Sub: Forests - Forest (Conservation) Act, 1980 –Trichy Circle /
Thanjavur Forest Division – Proposal (FP/TN/Road/149622/
2021) for diversion of 0.82 ha of forest land for initial
rectification including widening, strengthening and
improvements and performance based maintenance
contract for a period of 60 months in State Highways and
major district roads – Widening of Thiruverumbur – grand
Anaicut road – in favour of the Assistant Divisional Engineer,
Highways Construction Maintenance, Thiruvaiyaru – Site
inspection Report – Forwarding of - Regarding.

Subject: Diversion of 0.82 ha of forest land for initial rectification including widening, strengthening and improvements and performance based maintenance contract for a period of 60 months in State Highways and major district roads-Widening of Thiruverumbur-grand Anaicut road-in favour of the Assistant Divisional Engineer, Highways Construction & Maintenance, Thiruvaiyaru- Reg

Site Inspection Report

Name of the proposal: Diversion of 0.82 ha of forest land for initial rectification including widening, strengthening and improvements and performance based maintenance contract for a period of 60 months in State Highways and major dis

Google earth images of Proposed Road and CA land

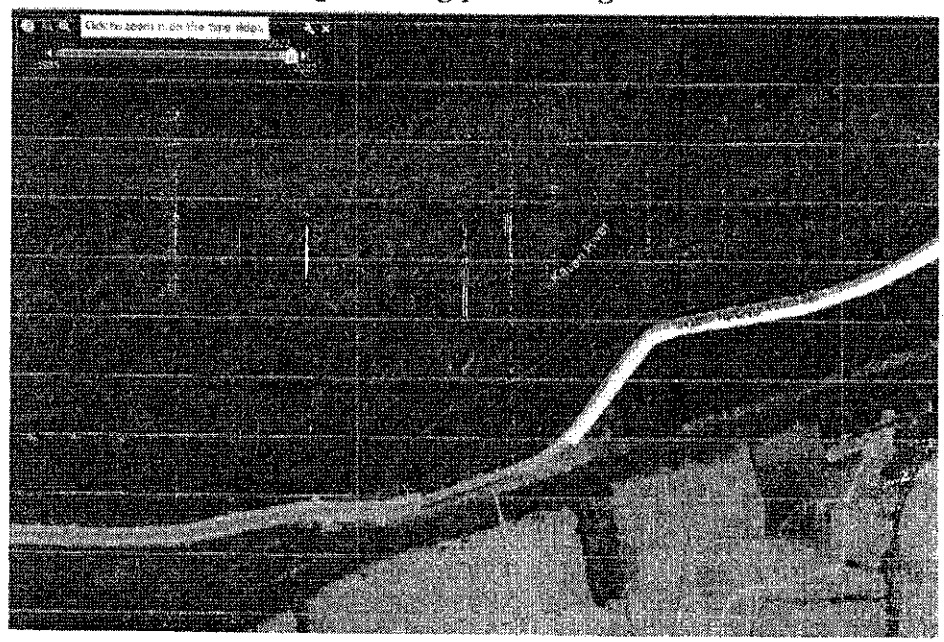
Proposed CA area is lying adjoining to the road but located in the edge of the river bank. It was informed by the field officials and the UA that due to the last year flood the area was inundated with water for some period. Moreover the proposed CA area is having thick growth of vegetation mostly of Prosopis species.

Based on the Site inspection and interaction with the field officials and User Agency and considering the possibility of water logging in the proposed CA area during peak flow of river, undertaking planting activities in the current proposed

CA area is not advisable. Hence the State Forest Dept may be requested to identify land in appropriate suitable degraded areas, where proposed 1200 seedlings can be planted and the seedling shall also be protected from the threat of cattle grazing / browsing.
